INTERNATIONAL ATOMIC ENERGY AGENCY
Division of Radiation and Waste Safety

CRITERIA FOR CLEAN-UP OF CONTAMINATED AREAS

Produced at the Consultants Meeting
24 to 28 June 1996

Vienna, Austria
Friday, 28 June 1996

Figure 2.1 Interpretation of the BSS to contamination situations.

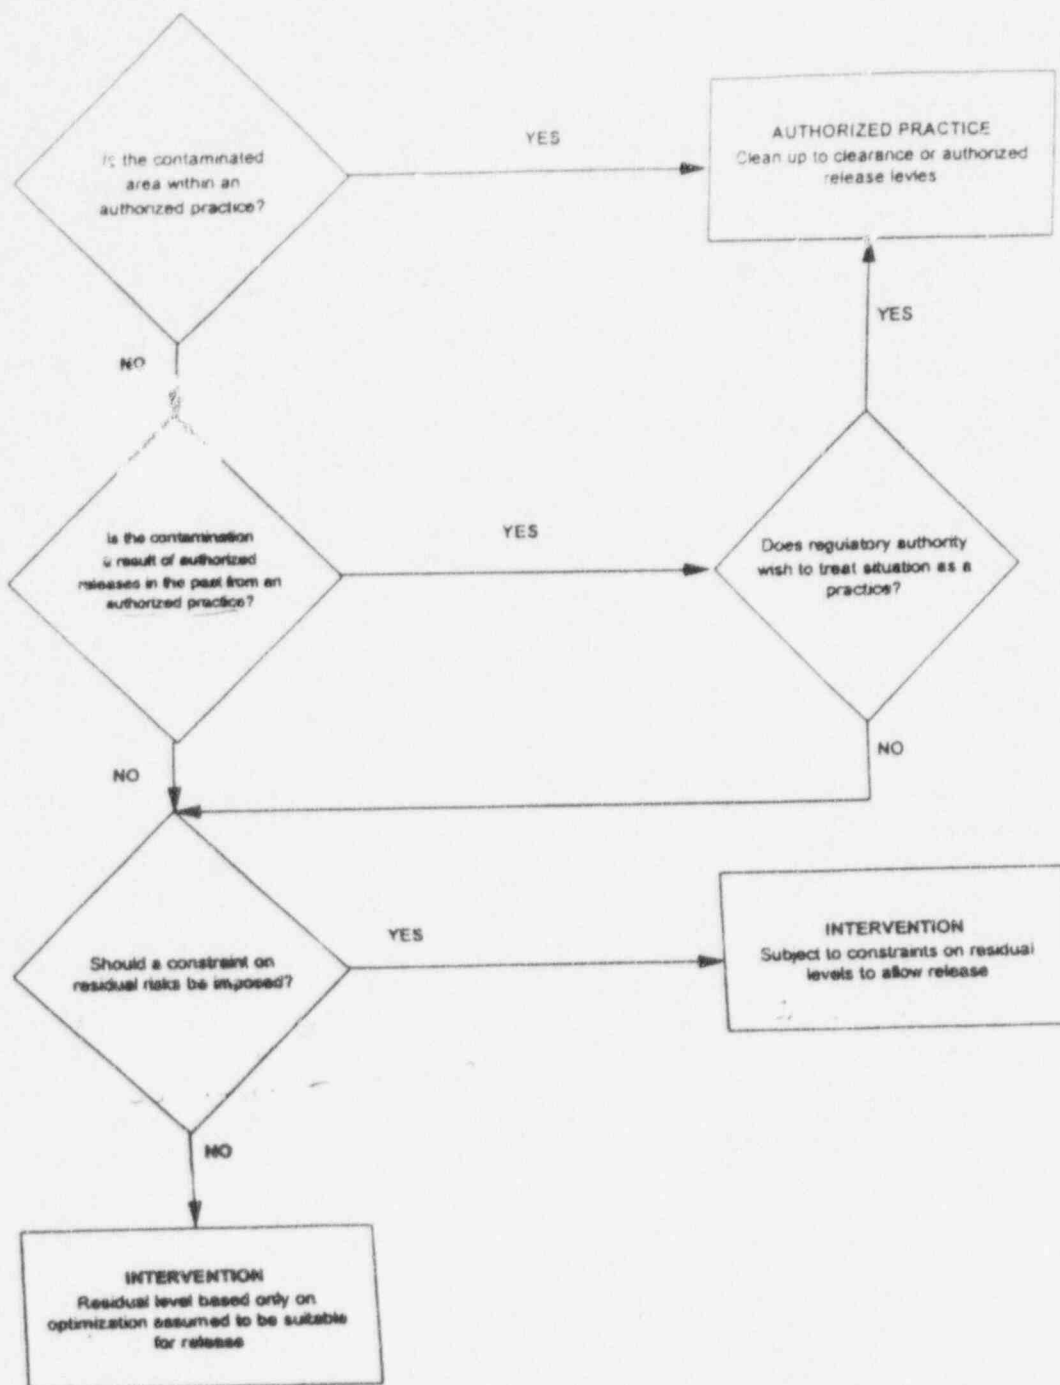
SAME SENTENCE
DOES THIS HAVE ANY PRACTICAL
SIGNIFICANCE? IF SO, NEED
TO EXPAND DISCUSSION

NO, FIGURE 2.2
FOUND IN TEXT
